Report of the Head of Development Management and Building Control Committee Report

| Case Officer: Christos Chrysanthou | 78464/APP/2024/3196 |

Site Address: **Dyson Drive, Uxbridge, UB10 0GJ**

Proposal: **The creation of 9no. off-street parking spaces and planting of 3no. new trees.**

Figure 3: Proposed Plan (please note – larger version of plan can be found in the Committee Plan Pack)

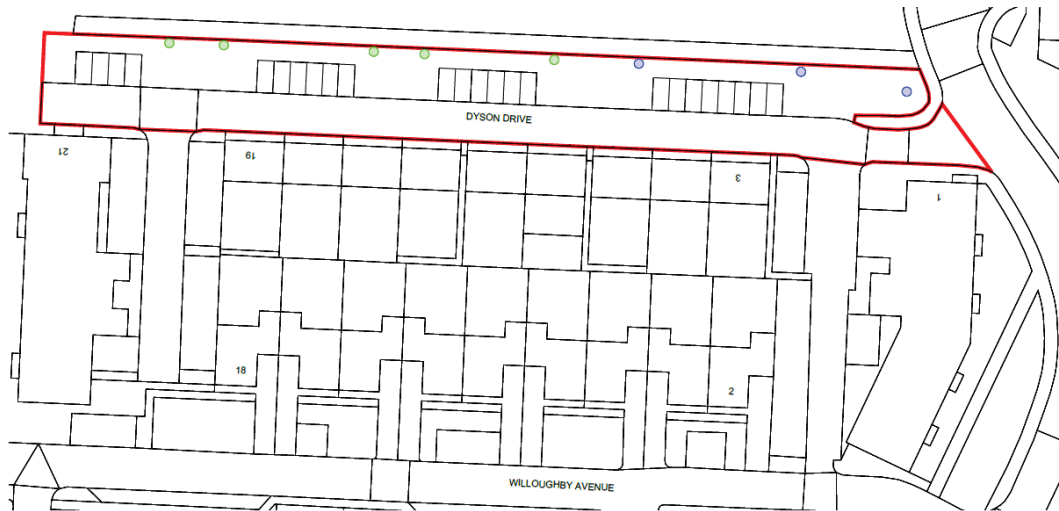
- 7.6 The proposed 9no. parking spaces would be allocated to homeowners on Dyson Drive. The Design and Access Statement suggests that the proposal would result in the removal of cars parking along the road and would improve the openness within the street scene. Drawing FLU.CP.02 titled 'Proposed Location and Site Plans' shows the proposed layout, which provides the additional car parking spaces adjacent to the existing rows of car parking spaces. Whilst the proposed arrangement would provide additional allocated parking spaces, due to the lack of parking controls on Dyson Drive, it is considered that the proposal would not resolve the existing informal parallel parking that currently occurs on the shared surface at Dyson Drive. It is therefore considered that the proposal could exacerbate the level of car parking and congestion on Dyson Drive.

- 7.11 The proposal would require the removal of green spaces alongside the existing parking bays to accommodate the new parking spaces. The new parking spaces are proposed to be surfaced with 'grasscrete'. Whilst an effort has been made to retain a green visual aspect, the proposed use of grasscrete is not considered to be a suitable or effective solution to offset the loss of green space.

- 7.12 The additional car parking spaces, the loss of green space, the proposed surfacing and the resulting proliferation of parked cars would be detrimental to the character of the area and would detract from the visual quality and usability of the landscaped pedestrian link, which is seen as an important part of the estate. The level of harm identified, is however on balance, not considered to be significant to warrant a separate reason for refusal.

- 7.14 There are no direct issues that are purely related to accessibility matters. However, it is worth noting that the proposed layout shows the car parking to be accessed via the shared surface, increasing the number of vehicle movements and therefore the potential risks for pedestrians and cyclists. This raises concerns on highway safety grounds, but is not considered to be a separate reason for refusal.
